Beaver Valley Power Station, Unit Nos. 1 and 2
Docket No. 50-334, License No. DPR-66
Docket No. 50-412, License No. NPF-73
License Amendment Request to Modify Technical Specification 3.1.3, "Moderator Temperature Coefficient Measurement (MTC)," to Provide an Exemption Under Certain Conditions

Evaluation of the Proposed Amendment

Subject: License Amendment Request for the Exemption of TS 3.1.3 Moderator Temperature Coefficient Measurement Under Certain Conditions

Figure 5.1-5 (Page 1 of 1)

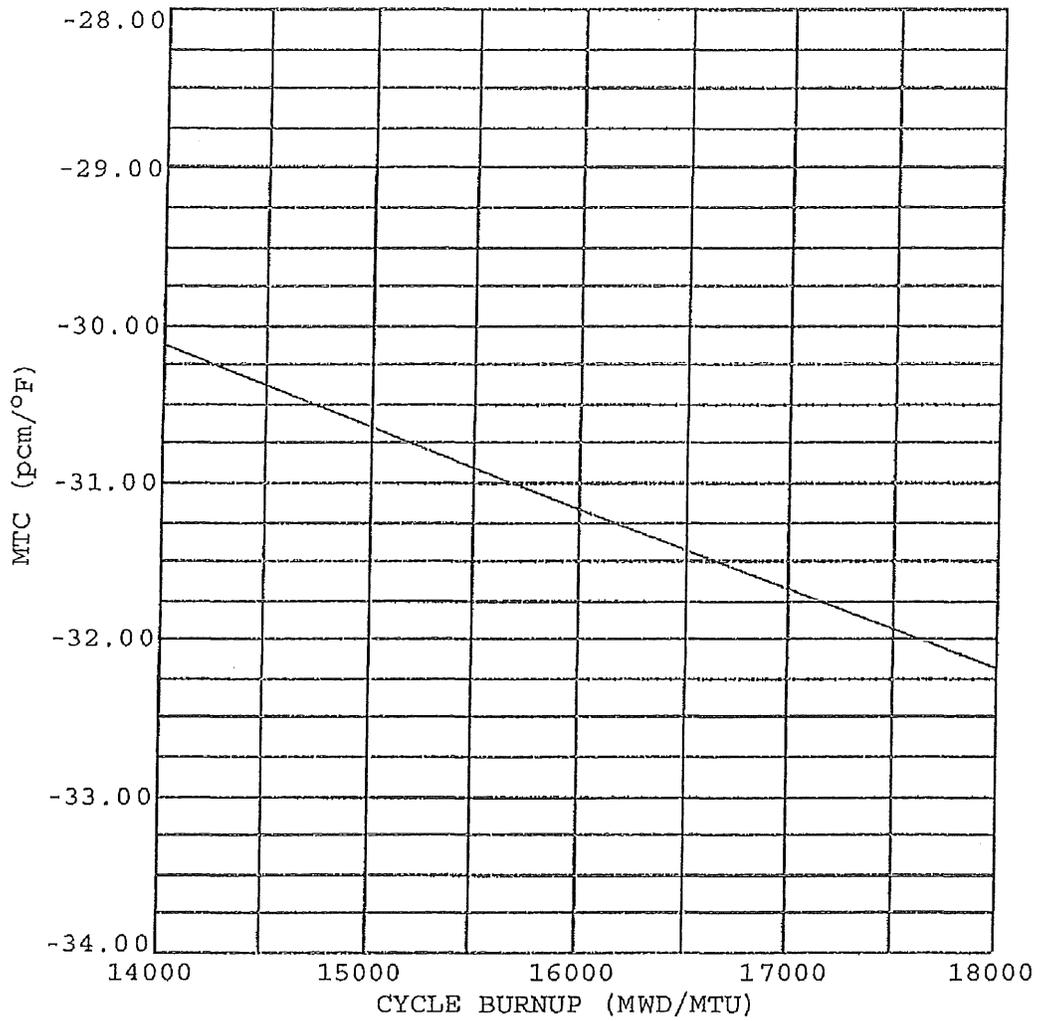
- a. Upper Limit - MTC shall be maintained within the acceptable operation limit specified in Technical Specification Figure 3.1.3-1.
- b. Lower Limit - MTC shall be maintained less negative than $-4.4 \times 10^{-4} \Delta k/k/^\circ F$ at RATED THERMAL POWER.
- c. 300 ppm Surveillance Limit: $(-37 \text{ pcm}/^\circ F)$
- d. The revised predicted near-EOL 300 ppm MTC shall be calculated using Figure 5.1-5 and the following algorithm from Reference 11:

$$\text{Revised predicted MTC} = \text{Predicted MTC} + \text{AFD Correction} + \text{Predictive Correction}$$
If the revised predicted MTC is less negative than the SR 3.1.3.2 limit (COLR 5.1.3.c) and the benchmark criteria contained in WCAP-13749-P-A are met, then an MTC measurement in accordance with SR 3.1.3.2 is not required.
- de. 60 ppm Surveillance Limit: $(-43 \text{ pcm}/^\circ F)$

Figure 5.1-5 (Page 1 of 1)

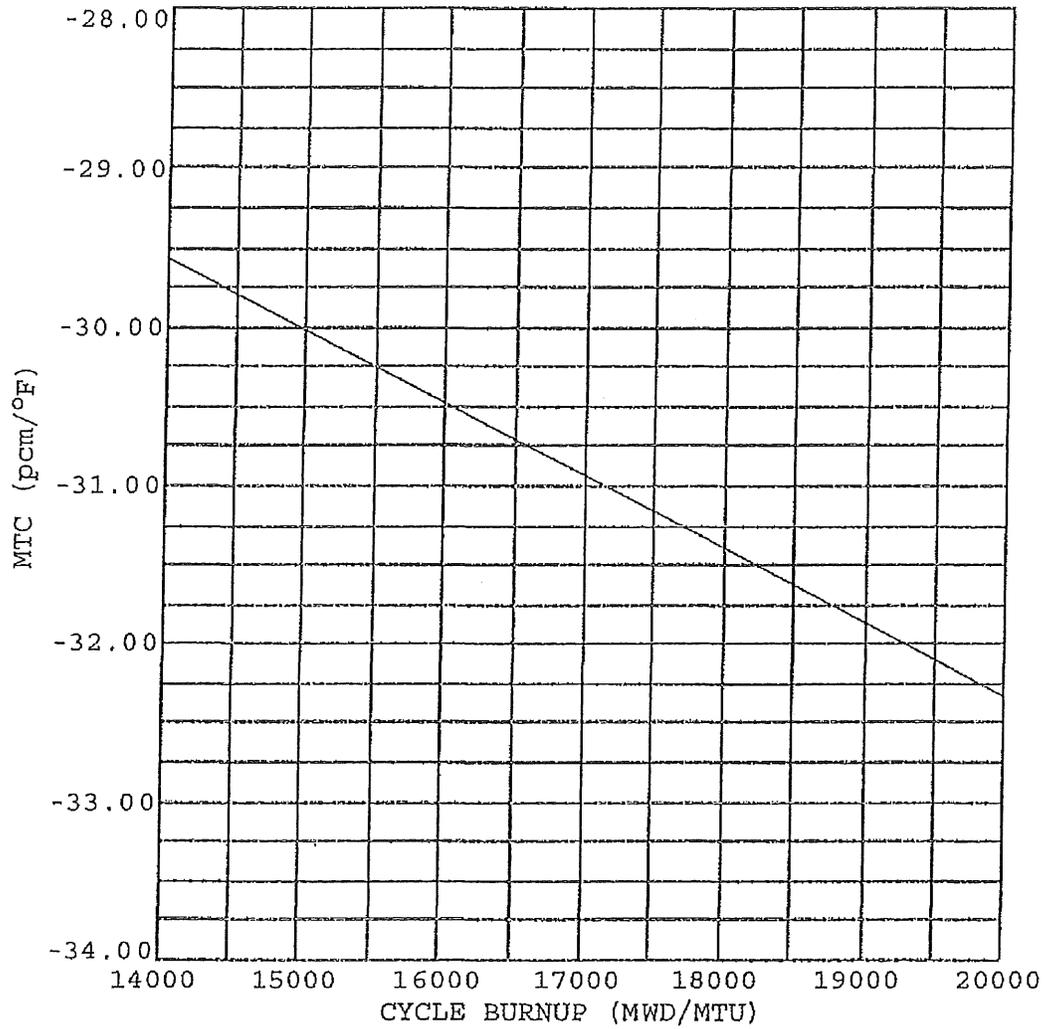
- a. Upper Limit - MTC shall be maintained within the acceptable operation limit specified in Technical Specification Figure 3.1.3-1.
- b. Lower Limit - MTC shall be maintained less negative than $-4.29 \times 10^{-4} \Delta k/k/^\circ F$ at RATED THERMAL POWER.
- c. 300 ppm Surveillance Limit: $(-35 \text{ pcm}/^\circ F)$
- d. The revised predicted near-EOL 300 ppm MTC shall be calculated using Figure 5.1-5 and the following algorithm from Reference 10:

Revised predicted MTC = Predicted MTC + AFD Correction + Predictive Correction

If the revised predicted MTC is less negative than the SR 3.1.3.2 limit (COLR 5.1.3.c) and the benchmark criteria contained in WCAP-13749-P-A are met, then an MTC measurement in accordance with SR 3.1.3.2 is not required.
